IS2062/IS2064/BM62/BM64 Data Sheet Errata

Affected Devices

Erratum	Affected Devices
EEPROM Content Corruption During Power Drop	IS2062, IS2064, BM62, and BM64

Figure 1-1. EEPROM Corrupted Data

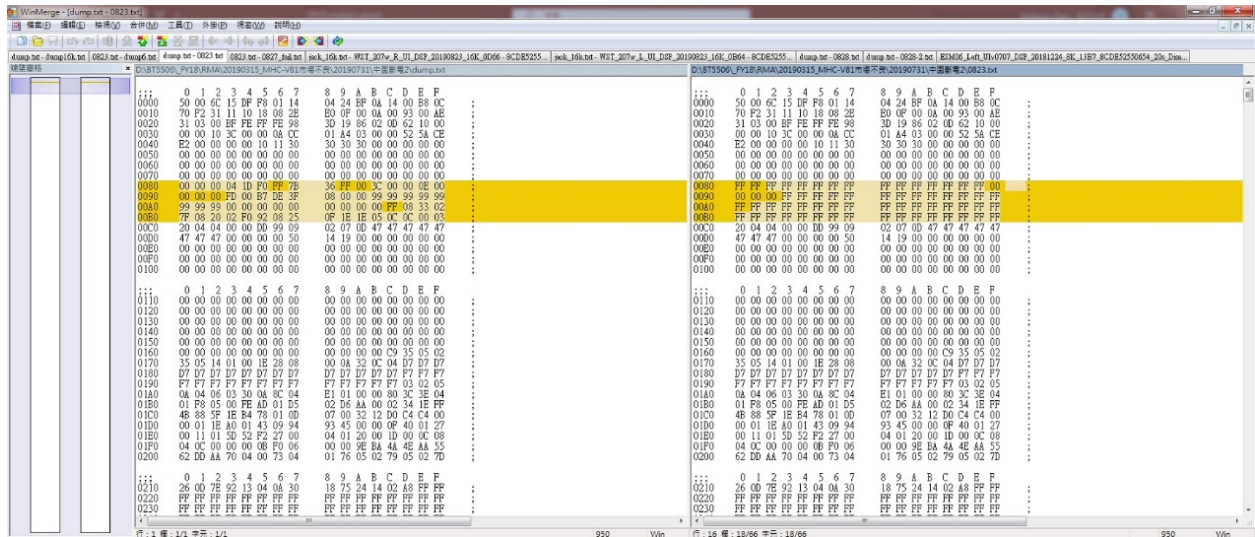
Under certain conditions, EEPROM content within the IS206x Bluetooth® Audio SoC can be corrupted with a specific pattern, a 64-byte sequence of 0xFF.

EEPROM write operations are typically performed within the IS206x SoC at runtime during, but not limited to, device pairing, shut down or while resetting to default configuration.

If power goes down during the EEPROM write operation before it is completed, then a page of data in EEPROM may be corrupted. The first operation in an EEPROM write is a page-erase operation and typical evidence of EEPROM corruption is a 64-byte sequence of 0xFF.

TWC (Total Write Time Cycle) for the EEPROM to complete an EEPROM write operation is 5 ms. A sudden power drop during the EEPROM write operation can result in corruption of EEPROM data in the page where the data byte resides since the writing of the data has not completed after the page erase process due to insufficient time allowed (5 ms). The page erase action will cause 64 bytes to become 0xFF before the data writing inside the page has concluded.

Figure 1-2. IS2062/IS2064/BM62/BM64 with Capacitor

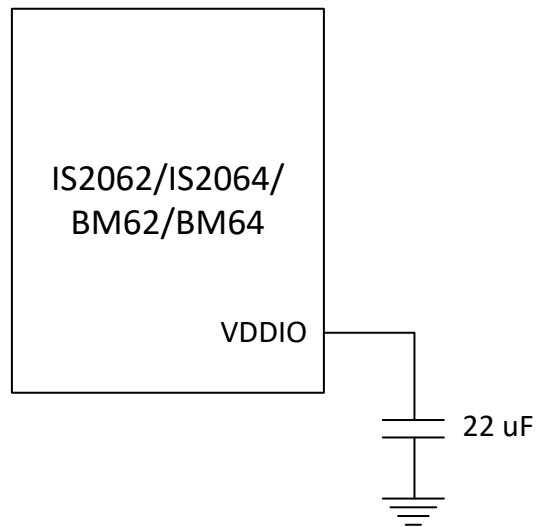
Add a capacitor on the VDDIO power pin to delay the power drop to the EEPROM voltage supply line so that the TWC requirement may be met.

Both IS2062/IS2064 and BM62/BM64 data sheets specify an external Reset IC to protect the system from power drop. In addition to this protection IC, a 22 uF to 100 uF capacitor is suggested to add on the VDD_IO pin for delaying the power drop timing.

Figure 1-3. RST_N Signal and VDDIO Drop Timing Sequence

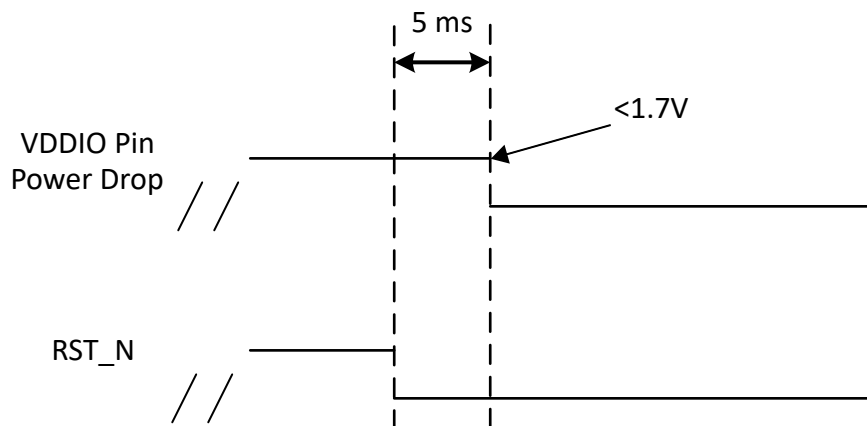
Timing sequence for the RST_N signal and VDDIO drop is shown in the following figure.
